Re: Submission to AMENDED State Significant Development No. SSD 16-7684

Site: 241-249 Wheat Road, Cockle Bay

Proposal / Proposed Development: Stage 1 Concept ('Built Form Envelope')

Submission on behalf of: Tianlong Ribbon Pty Ltd (Future Owners of 'The Ribbon Hotel' at 31 Wheat Road)

Figure 12 - Reduction in scale

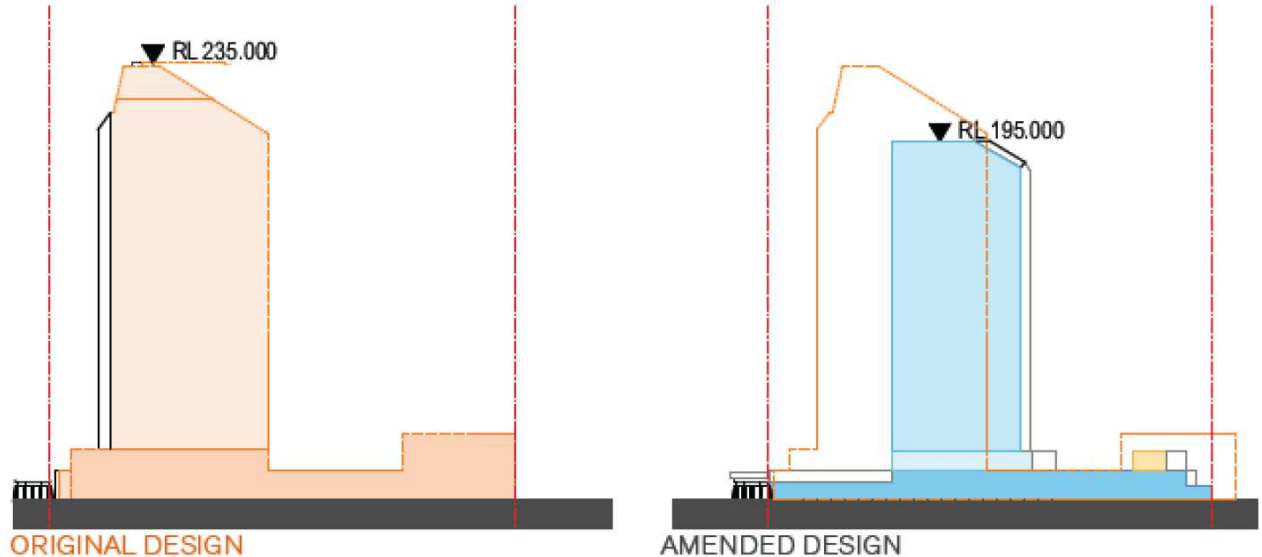
- 2.1. **Primary Tower Height:** The primary tower envelope has reduced in height from a maximum of RL235 to RL195 (see Figure 12 below), falling to RL179 in south-west corner. However, at RL195 this building still dominates the waterfront and surrounding buildings (see visual study below) and is potentially inconsistent with the city skyline and lowering of heights towards Cockle Bay. Whilst our client agrees that a 'point tower' is likely to have less impact than a squat continuous 'podium wall' building (of similar GFA) and the site can certainly support some height and FSR, the amended scheme does not produce appropriate urban design and amenity outcomes consistent with the planning for the Darling Harbour area.

- 3.1. Push the Primary Tower at least another 10-15m north whilst providing good separation to Pymont Bridge and public open space;
- 3.2. Reduce the Primary Tower height to at least RL150 with no additional penetrations for roof articulation above that height;
- 3.3. Reduce the Ground Level Envelope at the southern end to accord with the indicative design shown for the Druiitt Street pedestrian bridge/waterfront access i.e. not permit it to extend to the southern boundary of the lease.

Figure 15 - Height and Scale relationship

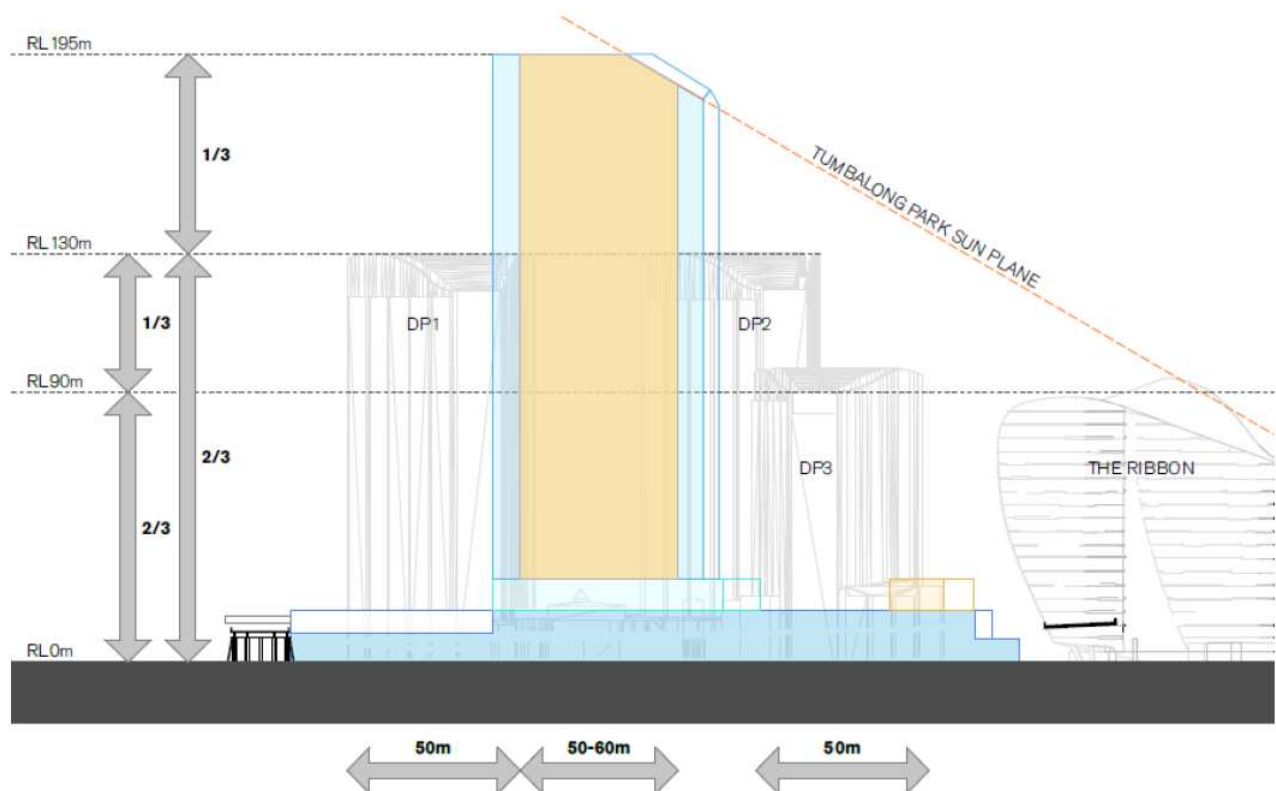
2.2. **Primary Tower Proportion:** The proportional scale argument suggested by Figure 15 above (and page 59 EIS) is weak and is driven strongly by the Tumbalong Park Sun Plane. Stepping up building heights towards the waterfront, particularly when the tower will only have a minimum 6m setback from the lease boundary/podium, will dominate the waterfront and surrounding buildings. Whilst the EIS seeks to use Barangaroo as a supporting departure from the 'valley floor' principle for building height this is an inappropriate precedent and too far removed from the context of the site. The Applicant's reference to The Ribbon height (page 59 EIS) in no way supports the proposal when it is approximately twice the height of The Ribbon.

Figure 10 - Relocation of tower

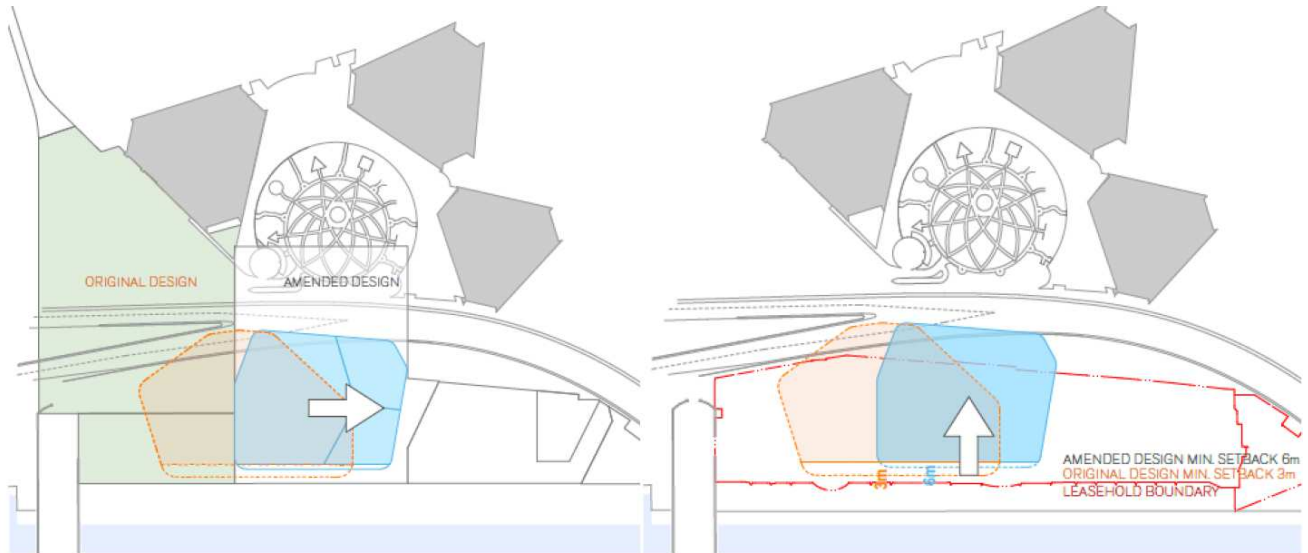
- a) The primary tower envelope has moved south by ~30m i.e. closer to The Ribbon Hotel (see Figure 10 above). This is called the 'Central Tower' option (in comparison to the original 'Northern Tower' option in the original scheme). In the original proposal the southern edge of the primary tower was ~130m from the southern edge of the leasehold boundary. In the Amended proposal it is closer to 100m.
- b) The reduction in height appears to be solely in response to the shift in the tower location to the south but it still seeks to achieve the maximum height under the Tumbalong Park Sun Plane (see Figures 12 & 15 above). In effect, the reduction in height of the tower does not improve the bulk/scale/shadow relationship to The Ribbon Hotel and adjacent waterfront area as the reduced height is offset by greater proximity.

- b) However, as Figure 10 above shows, whilst the bulk of the envelope floorplate has decreased in a north-south direction it is now squarer in shape and instead of narrowing to the south (to reduce the scale/bulk to the south and potentially allow greater penetration of morning sun to the southern waterfront) it is wider and bulkier at the southern edge of the tower.
